Docket: NRC-2016-0074
 Sequoyah State-of-the-Art Reactor Consequence Analyses

Comment On: NRC-2016-0074-0001
 Sequoyah State-of-the-Art Reactor Consequence Analyses; Draft Technical Report

**Comments on the NRC's draft technical report titled
"State-of-the-Art Reactor Consequences (SOARCA) Project:
Sequoyah Integrated Deterministic and Uncertainty Analyses"
(March 2016) for the NRC public meeting in Soddy-Daisy, TN**

**David Lochbaum
Director, Nuclear Safety Project**

Figure ES-2 Iodine release to the environment for variations of unmitigated STSBO and LTSBO

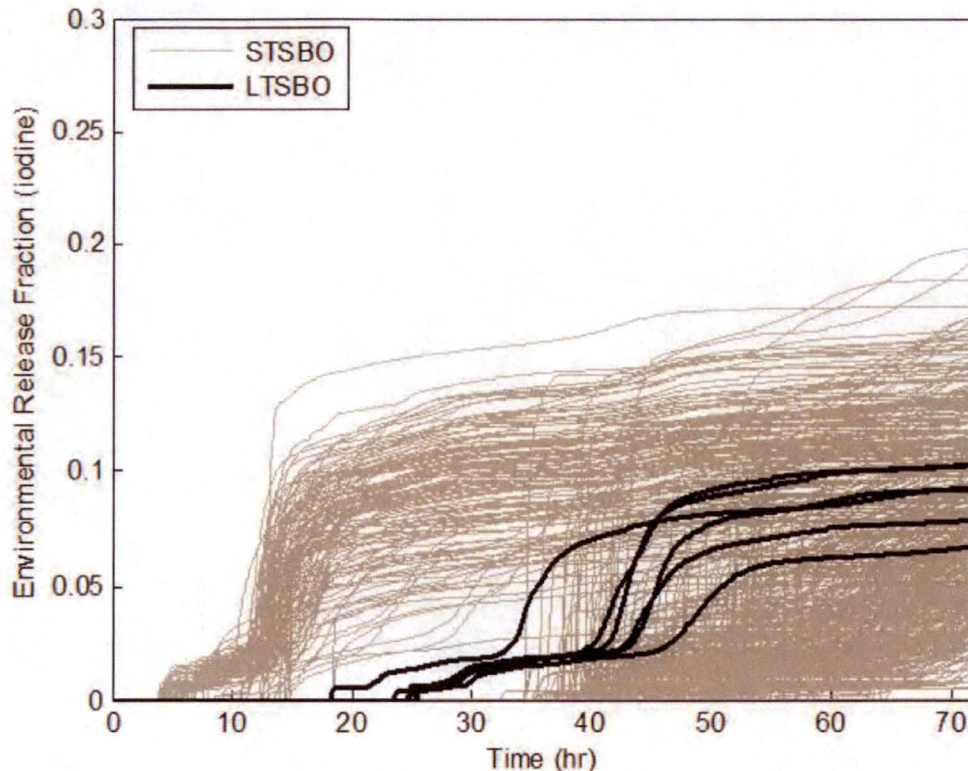
The draft report concludes that even in the worst case among the scenarios considered (the STSBO with releases occurring in as little as about four hours after the earthquake), there will be very little radiation exposure by members of the public, and therefore minimal harm. The postulated releases of radiation are so high that if people do not evacuate in time, considerable harm can result.

UCS Comment: The draft report seems unbalanced in that it assumes on one hand that the beyond design basis earthquake causes extensive damage to safety systems at Sequoyah that workers are unable to mitigate, yet on the other hand that this same earthquake causes only limited damage to the infrastructure within the 10-mile emergency planning zone that responders are fully able to mitigate. The final report must redress this imbalance. An overly conservative approach on the reactor side paired up with an overly non-conservative approach on the public protection side is not a prudent policy outcome.

Figure C-1 Assumed bridge failures and low lying areas within the EPZ

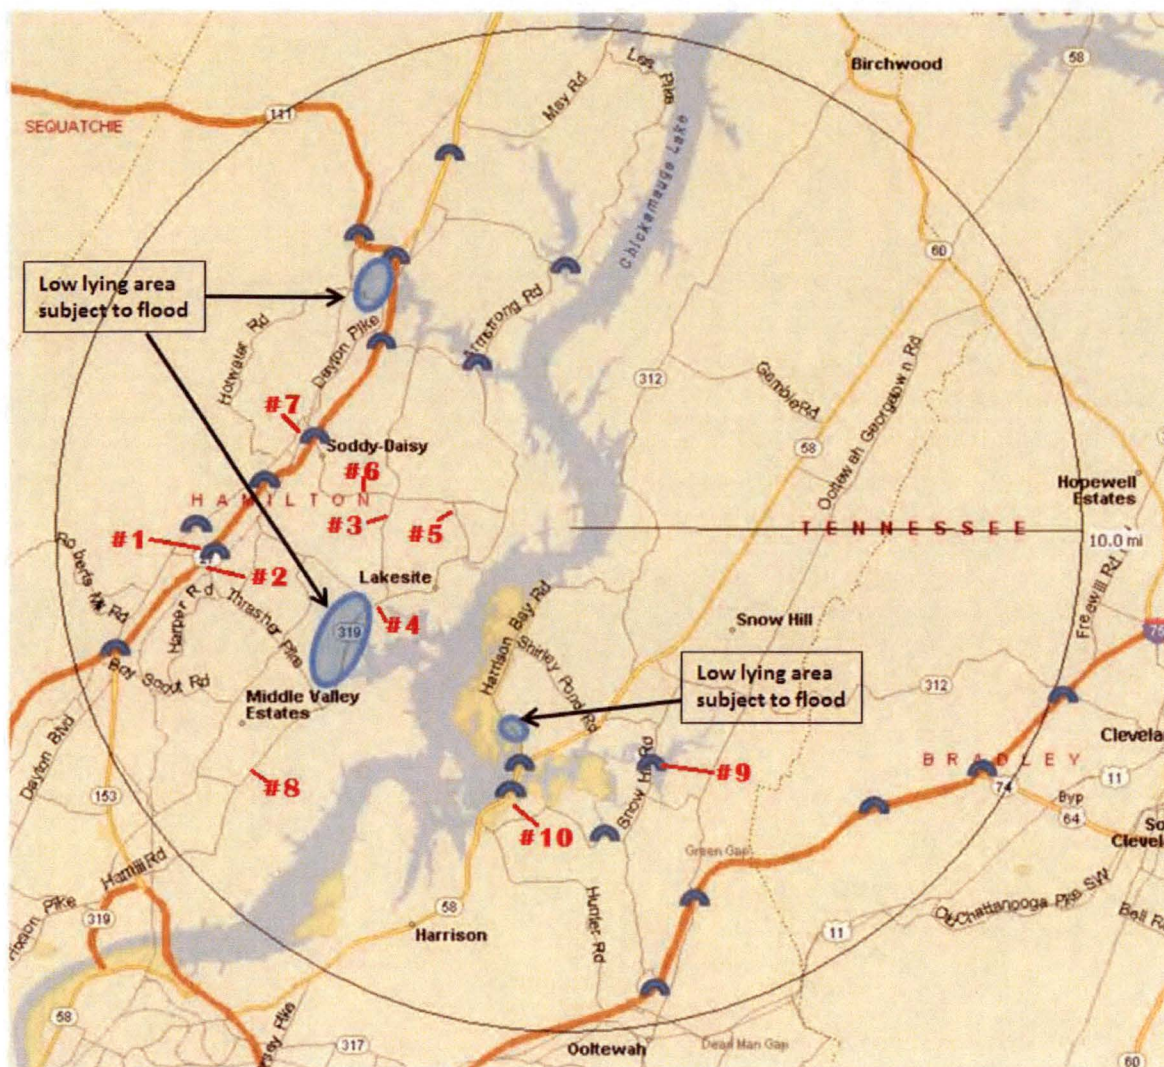
NRC Draft Report page C-3: "All bridges within the EPZ were assumed to fail due to the earthquake."

UCS Comment: The draft report states that all bridges were assumed to fail, but Figure C-1 only shows a subset of all bridges within the EPZ assumed to fail. Pictures #2, #4, #5 and #8 are bridges not shown on

Figure C-1 and presumably not assumed to fail. Pictures #4 and #8 show bridges on Hixson Pike (Highway 319), a four-lane major artery in the EPZ. If the draft report does not consider the failure of these bridges (which appear similar in age and construction to other bridges like #9 and #10 that are assumed to fail), failure of either bridge during a real event could significantly delay evacuations.

#1 – Thrasher Pike bridge over Highway 27 (shown on Figure C-1 as assumed to fail)

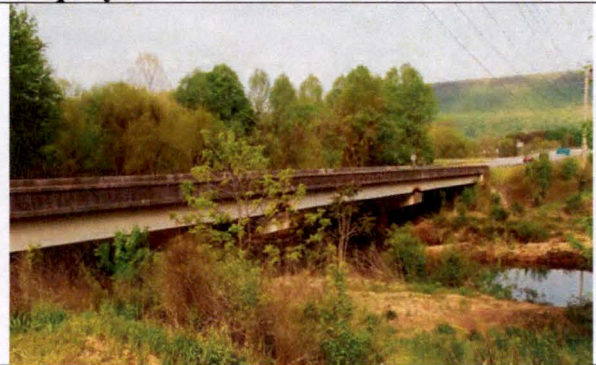
UCS Comment: The draft report considered that the postulated earthquake could damage bridges. But the draft report did not seem to consider other consequences from the postulated earthquake that could equally impact the infrastructure. As many of the pictures clearly show, poles often line one, if not both, sides of roadways. Downed power lines and/or fallen poles could impede evacuation pathways. But the draft report provided neither reasons why the poles/lines would withstand the earthquake's force nor evaluations of potential adverse consequences from downed lines and/or poles.
